EXPANSION & RENOVATE AS NEW – PHASE 1

**CRYSTAL LAKE ELEMENTARY SCHOOL
284 SANDY BEACH ROAD
ELLINGTON, CT 06029
STATE PROJECT NO. 048-0058 EA/RR/PS**

DATE: December 31, 2013

The following changes to the Drawings and Project Specifications shall become a part of the Drawings and Project Specifications; superseding previously issued Drawings and Project Specifications to the extent modified by Addendum No. 3.

Drawing Number:
SKA1
Bid Phase

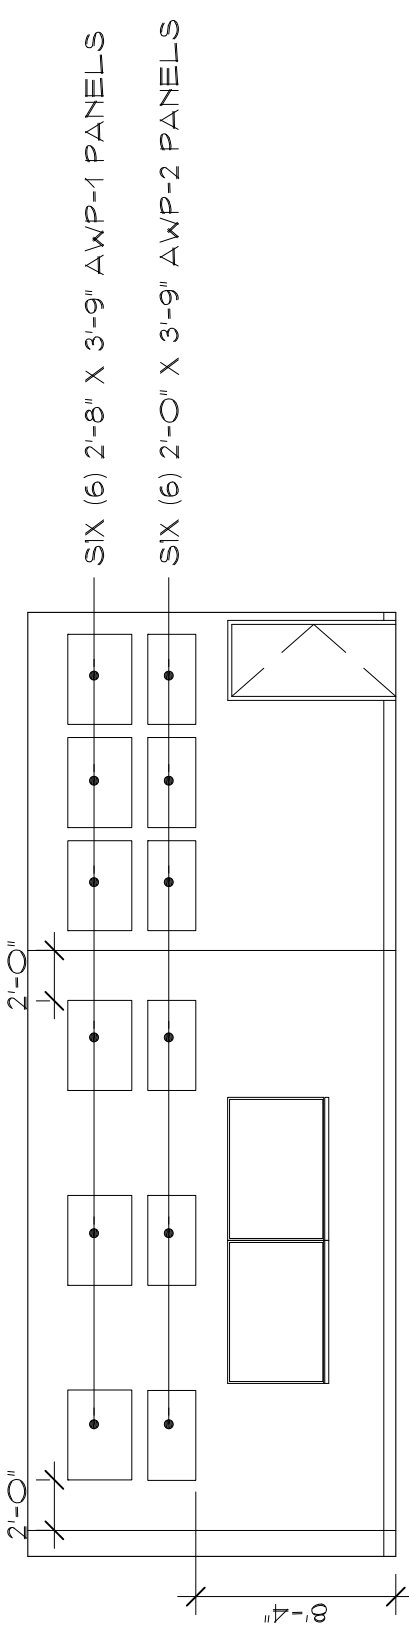
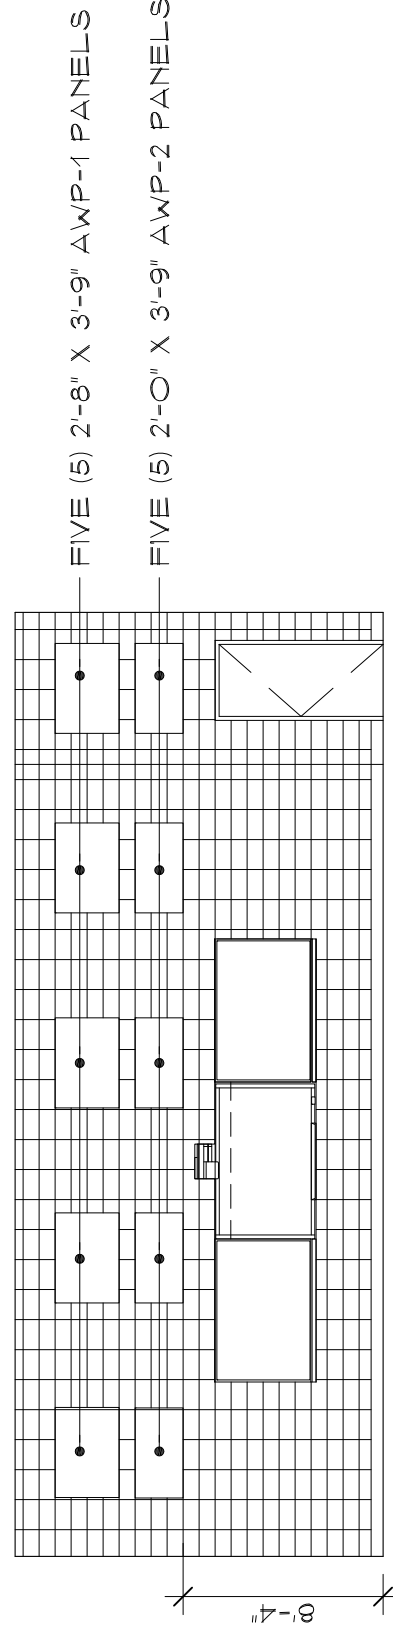
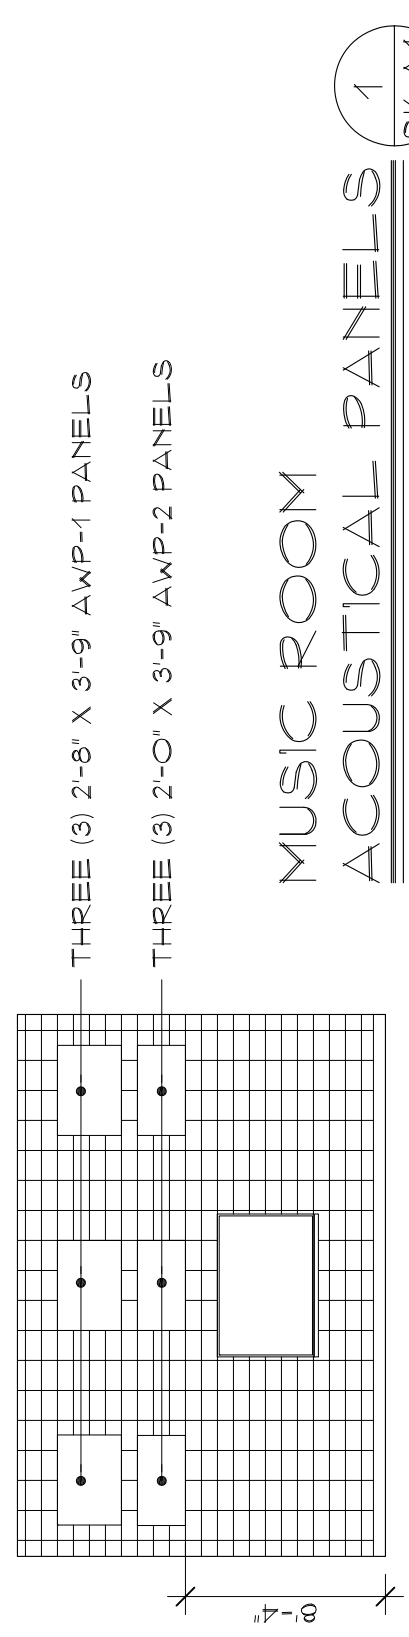
- DRAWING SK A1, Music Room Panels.
- DRAWING SK A2, Aluminum Curtain Wall Frames.
